TENNESSEE VALLEY AUTHORITY

TVA-SQN-TS-37

RELOAD SAFETY EVALUATION

SEQUOYAH UNIT 1, CYCLE 2

MAXIMUM CALCULATED VALUES OF $F_{\Delta H}^N$
 WITH RESPECT TO TECHNICAL SPECIFICATION LIMITS

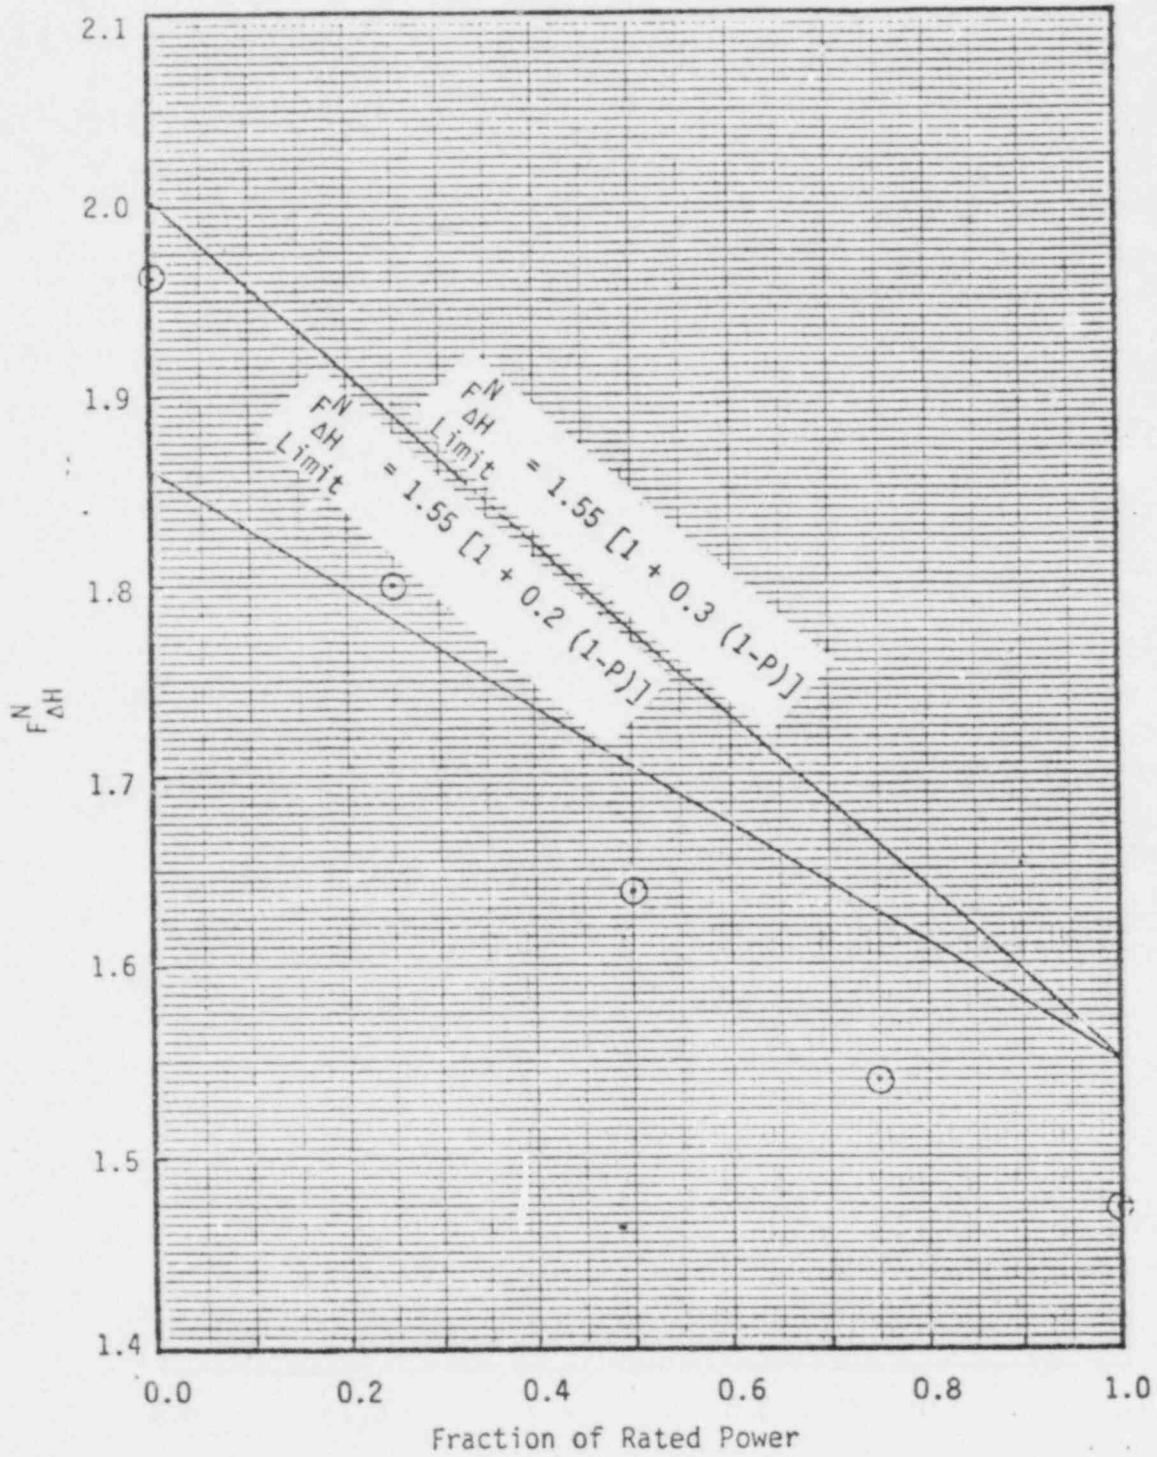
In the cycle 2 analysis, the $F_{\Delta H}^N$ limit scope was changed from 0.2 to 0.3. The change in $F_{\Delta H}^N$ with power is described by the following relationship:

$$F_{\Delta H}^N \leq 1.55 [1 + 0.3 (1-P)]$$

This allows an increase in allowable $F_{\Delta H}^N$ at reduced power in comparison to the previous technical specification limit while maintaining the same $F_{\Delta H}^N$ limit at full power. The increase in allowable $F_{\Delta H}^N$ at reduced power allows for optimization of the core loading pattern for full-power operation by minimizing the restriction on $F_{\Delta H}^N$ at low power. This eliminates the need to change the rod insertion limits to satisfy peaking factor criteria at low power with the control rod banks at the insertion limit. The variation in the maximum calculated $F_{\Delta H}^N$ with power with the control rods at the insertion limit for cycle 2 is shown in figure 2.

Revised Figure 2.1-1. Reactor Core Safety Limit - Four Loops in Operation

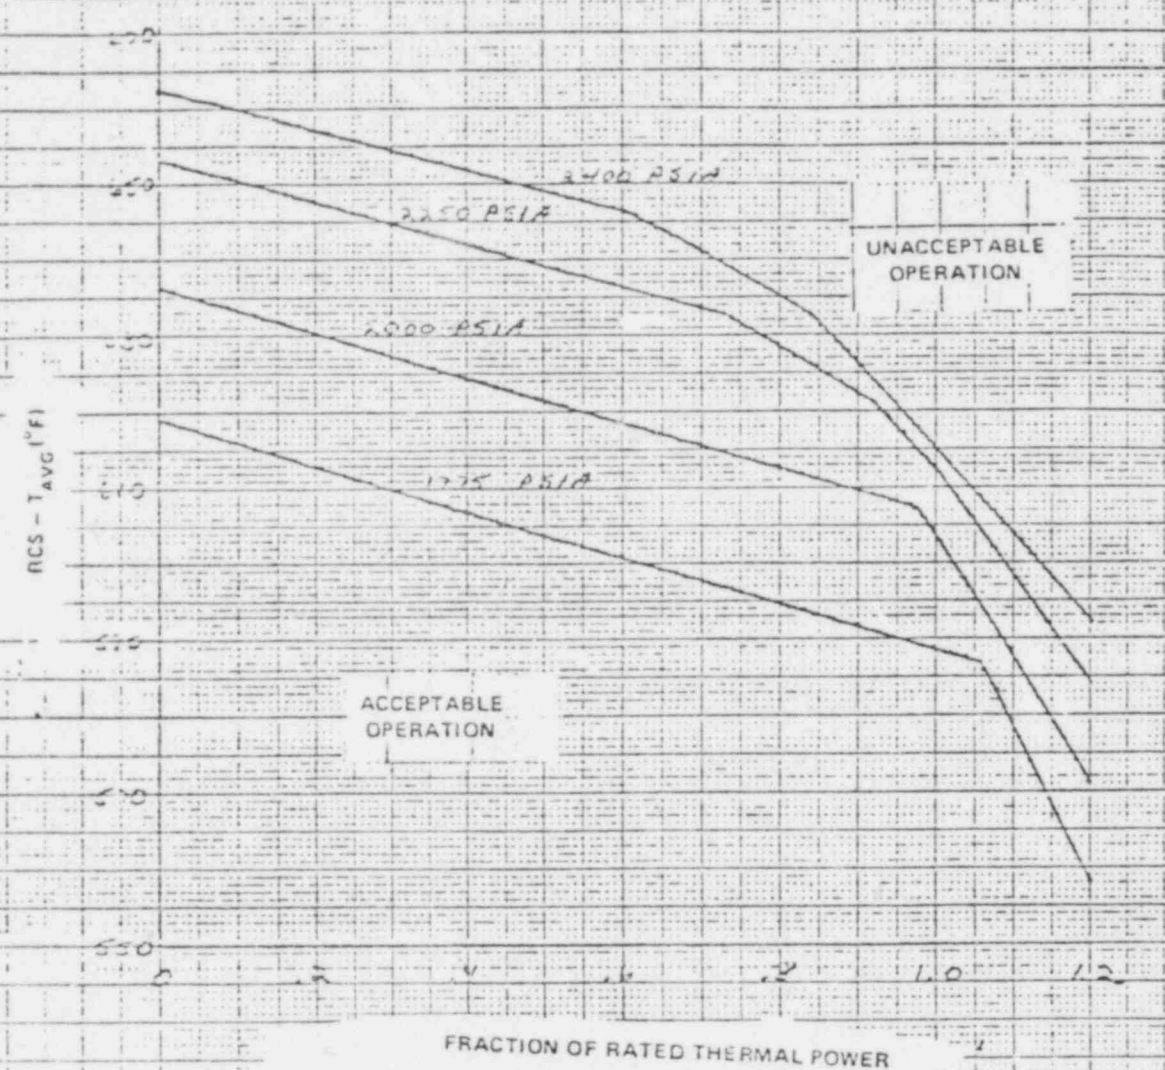
No significant variations in thermal margins result from the cycle 2 reload. However, the reactor core safety limits, figure 2.1.1 in the technical specifications, and the axial offset limits have been revised to reflect the increase in K from 0.2 to 0.3 in the following relationship.

$$F_{\Delta H}^N \leq 1.55 [1 + K (1-P)]$$

Where P = fraction of rated power for power levels less than 100 percent.

The core limits at 1775 and 2000 psia remain unchanged from the current limits. At 2250 and 2400 psia the proposed core limits are slightly more limiting below 100 percent power. The core limits have these minimal changes because, at most conditions below full power, the restriction that the average enthalpy at the vessel exit be less than the enthalpy of saturated liquid is more limiting than DNB considerations. This vessel exit enthalpy limit is not dependent on core peaking factor.
